Docket Items # 9 & 10
BAR CASE # 2009-0243 & 0245

BAR Meeting
November 4, 2009

ISSUE: Additions/Alterations and Waiver of HVAC Screening Requirement
APPLICANT: William Cromley, Applicant
LOCATION: 227 South Fairfax Street
ZONE: RM/ Residential Townhouse Zone

Figure 9: Proposed Changes – Duke Street Elevation

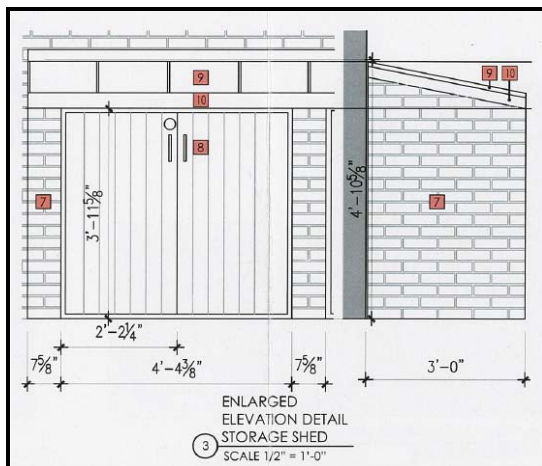
The applicant's request to convert an existing door opening to a window opening and a window opening to a door on the south ell was initially a concern for staff. However after site visits, the current physical evidence suggests that there have been alterations to this elevation. Staff finds that the proposal will not negatively impact the integrity of the resource as a whole, and considers the

interchangeability of a door to a window while retaining the opening widths, the jack arches, and re-using existing brick for the masonry repair, where possible, a typical evolution for a building and a minor change to this secondary elevation. Staff supports this requested change.

1. That the window being converted to a door on the south ell will retain its jack arch and the original width of the opening.
2. That the bricks being removed for the installation of the door on the south ell will be used, where possible, for the masonry infill required for the door to window conversion on the south ell.

Figure 21: HVAC – Proposed Location

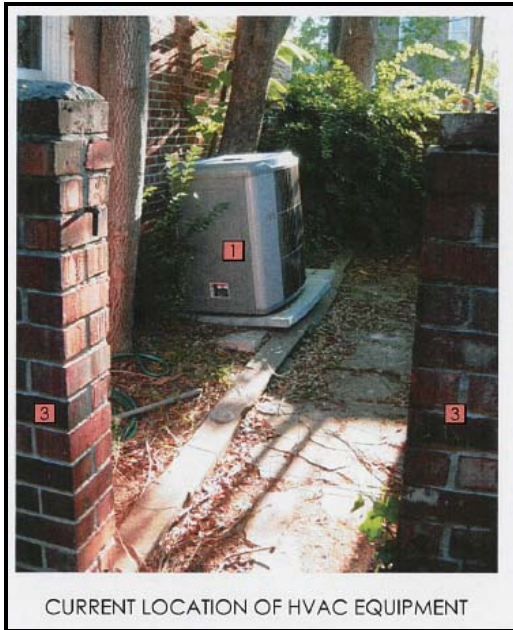
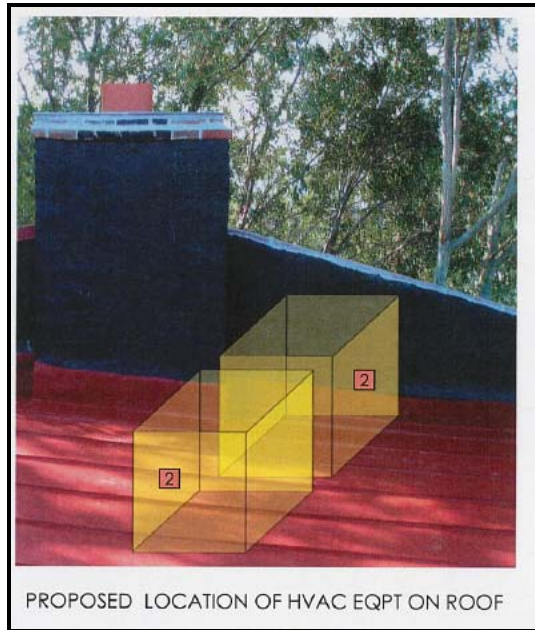
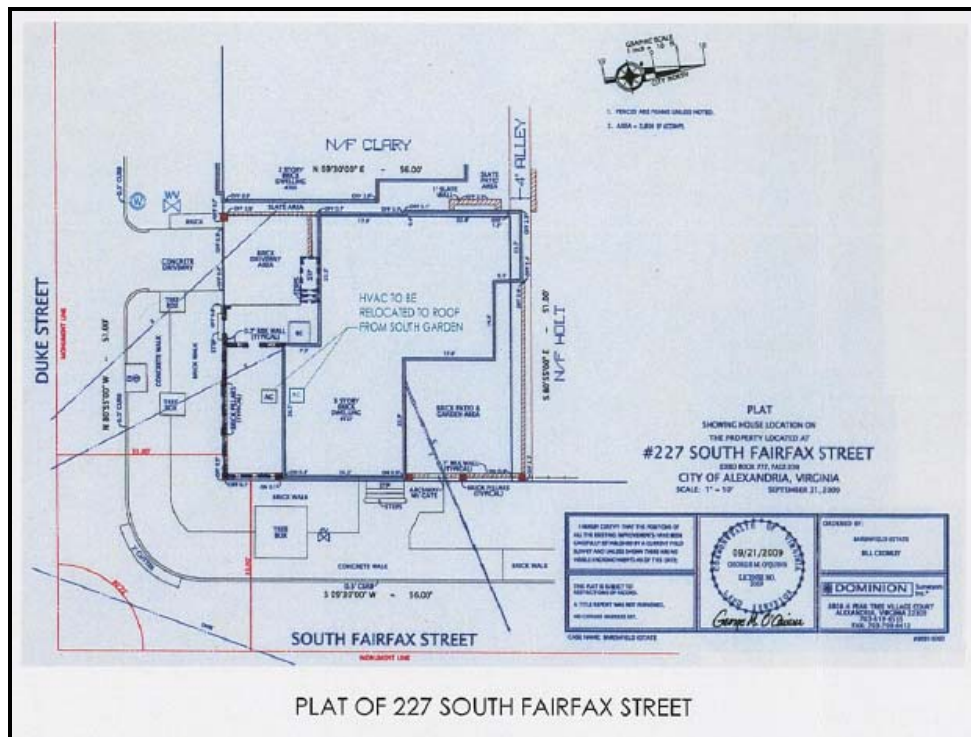
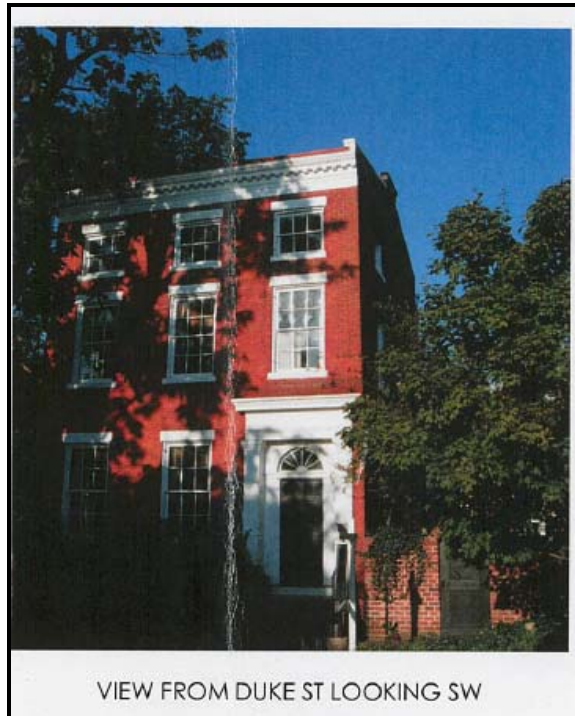
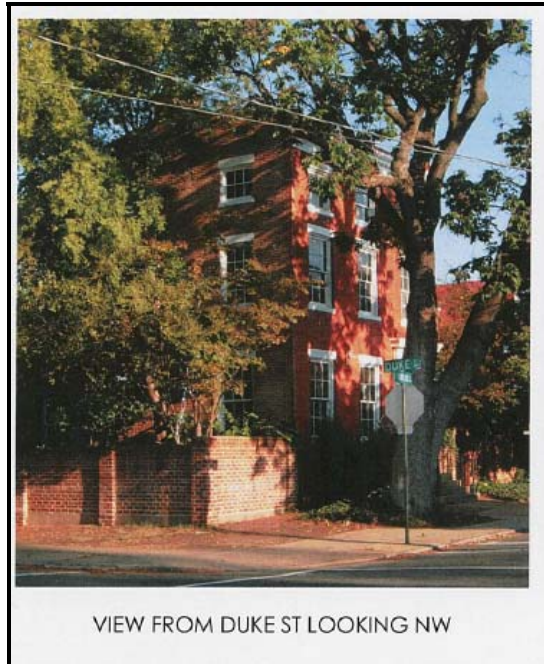
Staff finds the proposed placement of the HVAC equipment will be minimally, if at all, visible from South Fairfax Street or Duke Street. Additionally, it was recommended by staff to analyze the roof's structural system to ensure it can support the additional weight of the condenser units without requiring an alteration to its structural system. Based on the attached structural analysis (page 21), the condensers being sited on the roof will not negatively impact to the structural integrity of the historic resource. Staff recommends approval of the waiver.

Goughnour Engineering, PC has reviewed your proposal to place two mechanical units on the roof of the referenced residence. As we understand the units will weigh approximately two hundred pounds each and will be supported by the existing roof framing. We were able to determine that the roof is supported by 3"x6" deep joists spaced at sixteen inches on center. In our opinion, based on our understanding of the project and calculations, the roof framing is more than adequate to support the additional load of the units.
